# On The PoC Inductor Selection

July 28, 2025

Ahmad Chini  
Broadcom

IEEE 802.3dm Task Force

# New 6.8uH PoC Inductor!

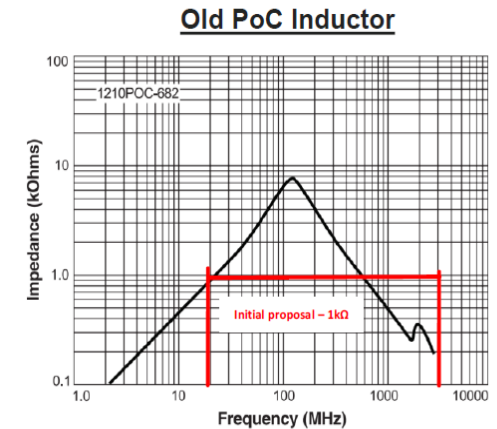
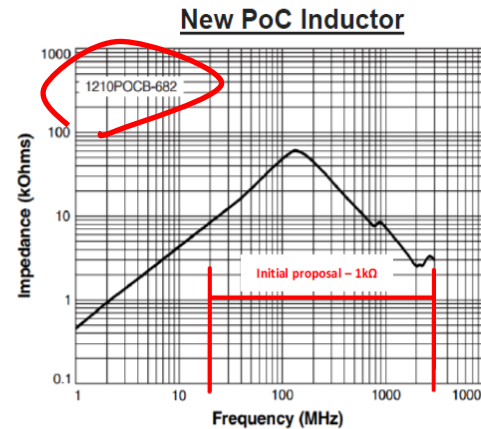
- The so called “New PoC inductor” plot<sup>1</sup> is easily calculated from low frequency impedance to be 68.2μH and **not** 6.8μH! (a typo?)
- The referenced link shows the plot for 1210POCB-682 which is a 6.82μH and not as shown in the presentation<sup>2</sup>. With that, the stated proposal of staying above 1kOhm over whole bandwidth is not achieved.
